# BULLETIN

## Opel Corsa-D

#### Front brake system

#### Squeaking noises when braking

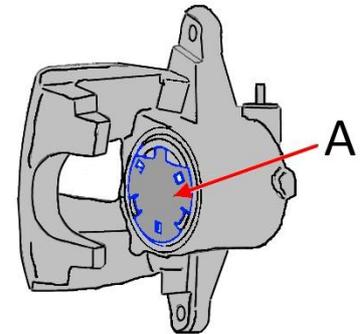
If the symptom specified above cannot be allocated to any detectable defect on the wheel brake, one possible cause of this is an insufficient decoupling between the brake pad and the brake caliper. For improving comfort, the vehicle manufacturers have installed so-called "Piston Caps" in the piston (A) of the brake calipers.

In case of a complaint, this must be checked and renewed where appropriate. On vehicles affected without "Piston Caps", these can be retrofitted.

These additional "Piston Caps" (B) have been introduced to the production from the following chassis numbers.

Eisenach: W0L0SDL0876108784

Zaragossa: W0L0SDL6874284654

Spare part number "Piston Cap": Vauxhall 93169307
